**Subject: Submission in relation to Permit Application P26807
Royal Exhibition Building: Promotion and Protection Works**

Royal Exhibition Building VHR1501 - Permit Application P26807 Comments upon the Proposed Dome Promenade Pavilion

Royal Exhibition Building – Proposed Dome Promenade Pavilion

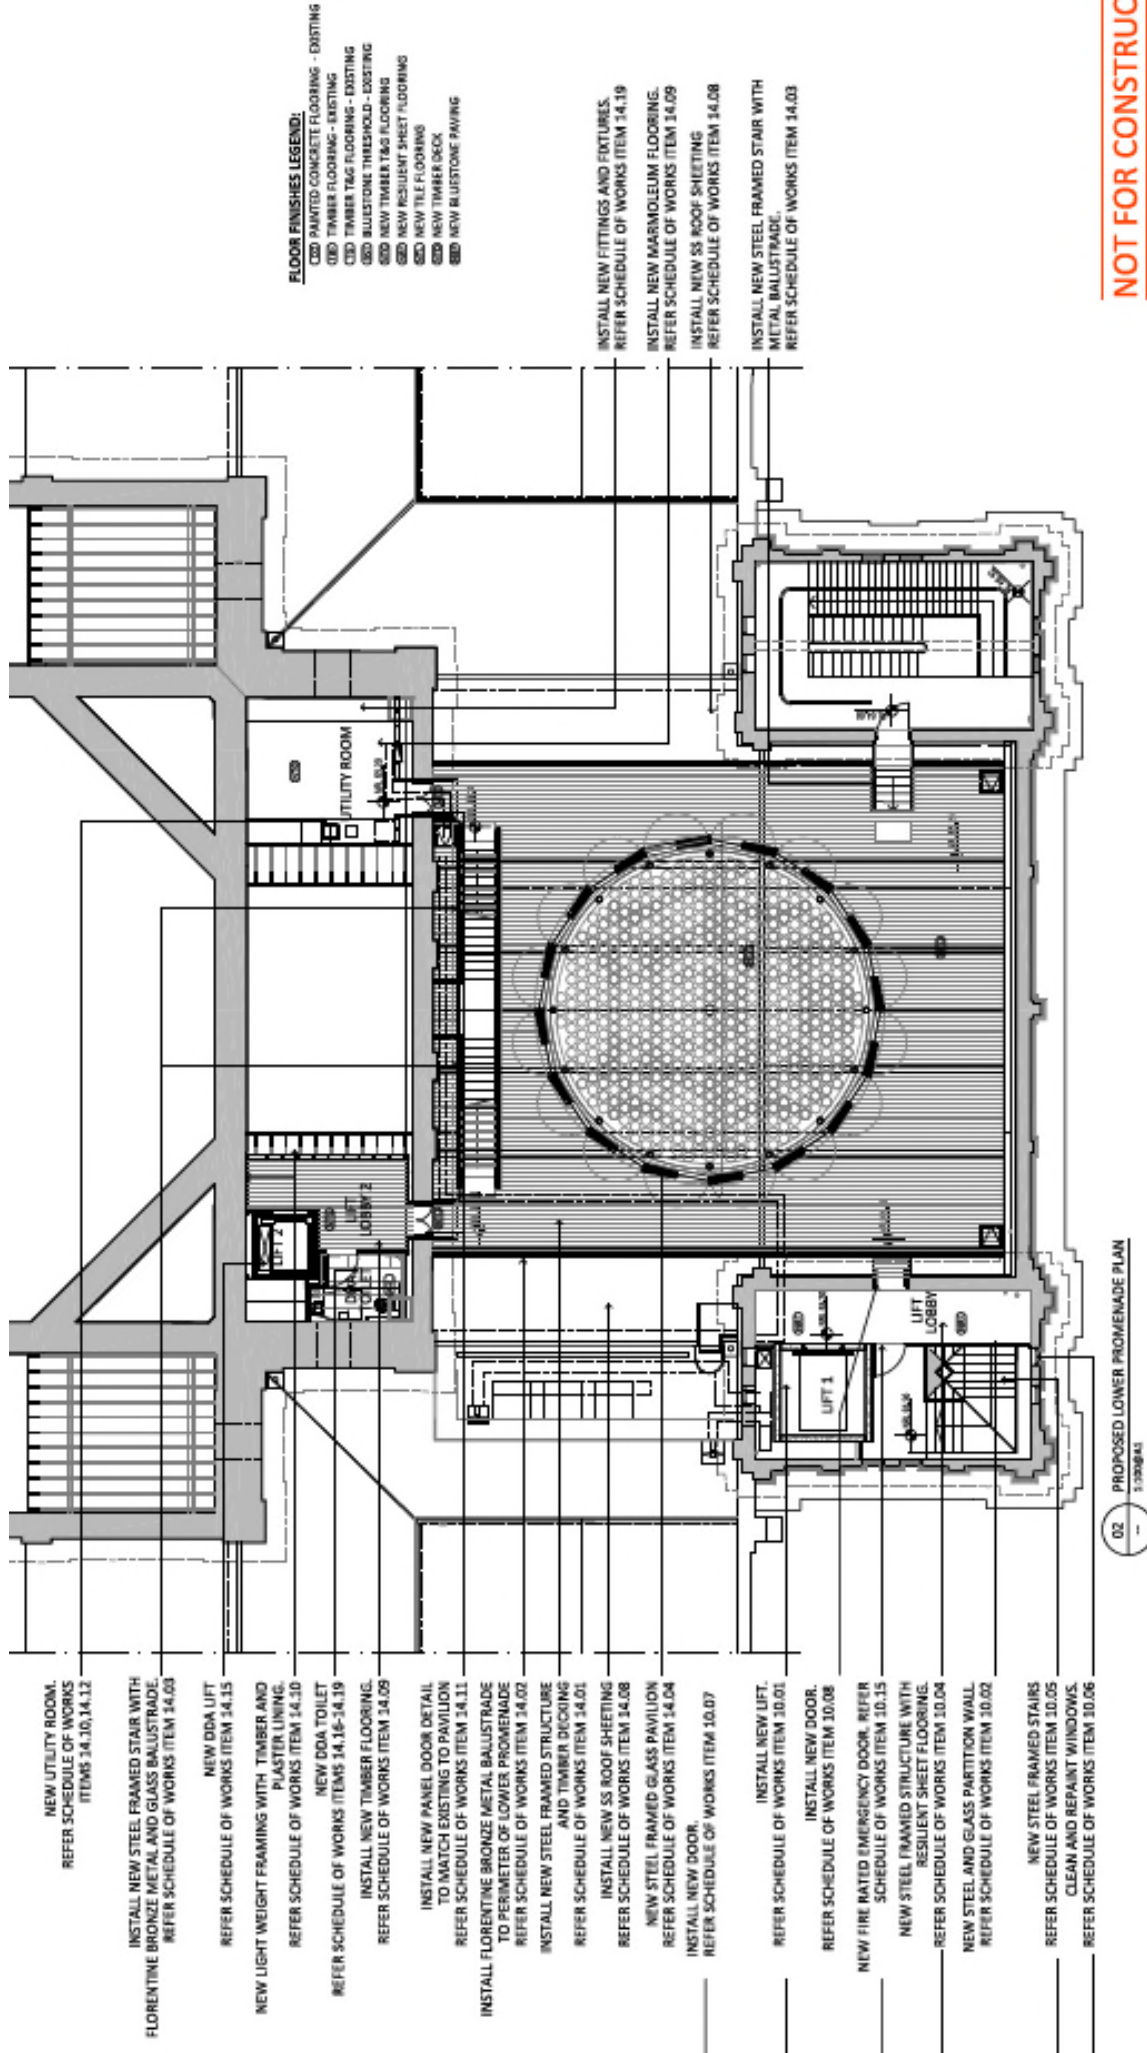
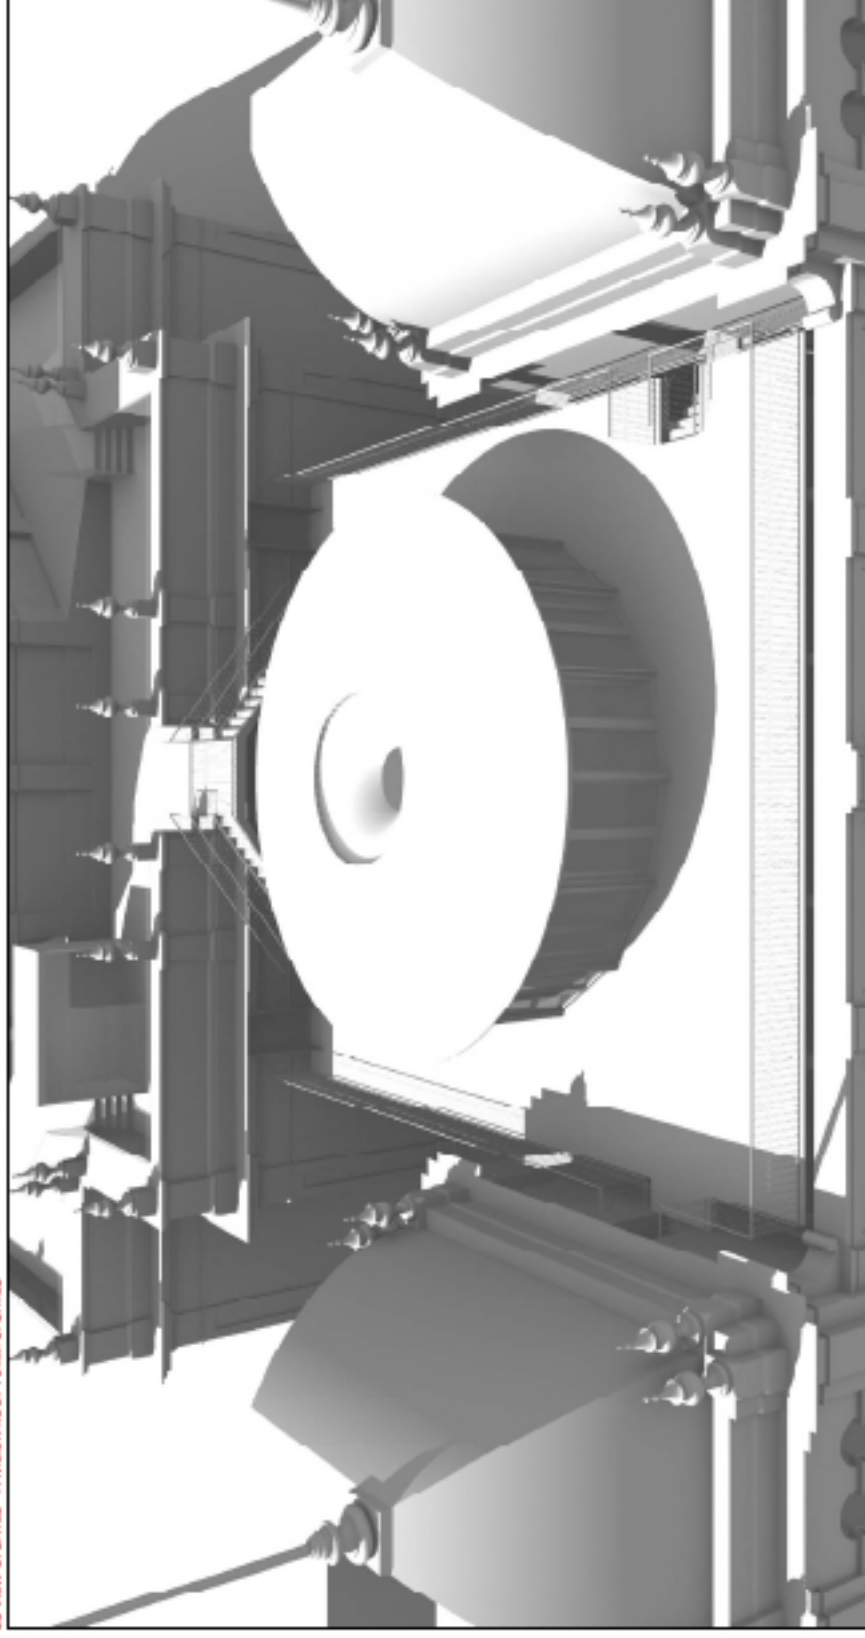
From the information presented in the drawings and the schedule of works, it is clear that this structure is no "simple" pavilion. While the steel framed glass pavilion may be conceived as a "light" structure, it takes up about 40% of the area of the lower promenade deck, and unlike many "light" pavilions, will be constructed to facilitate the provision of both mechanical and electrical services. No doubt, these services will be required so that the space can "generate income for Museum Victoria".

While the Photo Montage exhibits provided by the Applicant suggest that the proposed pavilion will be largely obscured when viewed from different vantage points in the Carlton Gardens, it will constitute a major new element when viewed from the upper promenade deck [see attachment]. Also, if the pavilion is used at night for income generating functions, the light spill will draw attention to this major new element.

Since the major purpose of the promotion works is to reinstate the Promenade Experience, it is not at all clear how the construction of a Pavilion and associated "Utility Room" on the lower deck will facilitate that experience. When these facilities are used for income generating functions, it is highly likely that access to the upper deck [and the promenade experience] will be restricted. Also, given that the new Pavilion will take up about 40% of the lower deck, this structure cannot avoid detracting from the appreciation of the original pavilions [stair "shafts"] and other roof elements of the REB when viewed from the upper deck. This would not be consistent with The Burra Charter [2013] guidance.
